Technical Service Bulletin

46 Squeal from front brakes

46 16 33 2042182/2 April 4, 2016. Supersedes Technical Service Bulletin Group 46 number 16-31 dated March 18, 2016 for reasons listed below.

Model(s)	Year	VIN Range	Vehicle-Specific Equipment
Q5	2013	047567 - 999999	2.0TFSI, 3.0TFSI, 3.0TDI with PR code 1LE or 1LB
Q5	2014 - 2017	All	2.0TFSI, 3.0TFSI, 3.0TDI with PR code 1LE or 1LB

Figure 1. Shims on back of front brake pads.

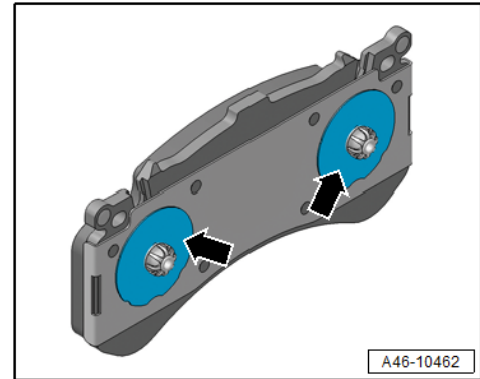
- Some vehicles may have two shims glued to the back of the front brake pads (Figure 1). **Do not** transfer these shims to the new pads.
- New brake pads have an adhesive backing that should be used to properly attach the pads to the caliper.

Figure 2. Location of pistons.

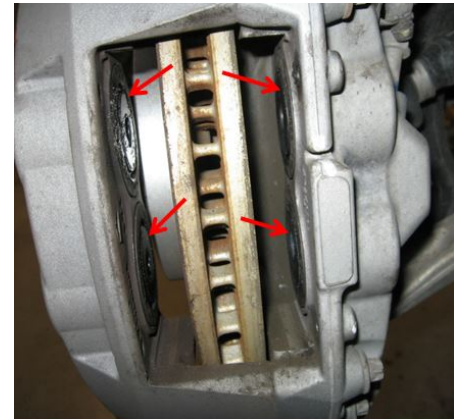
- Thoroughly clean and dry each piston (Figure 2, arrows) to ensure that the new pads will properly adhere to the pistons.
- Do not apply any lubricants to the pads or calipers.
- After the pads are installed in the calipers, apply full pedal pressure for at least 10 seconds to ensure proper adhesion of the pads to the pistons.
- In order to allow the glue to set, do not drive the vehicle for 10 minutes after new pads have been installed.
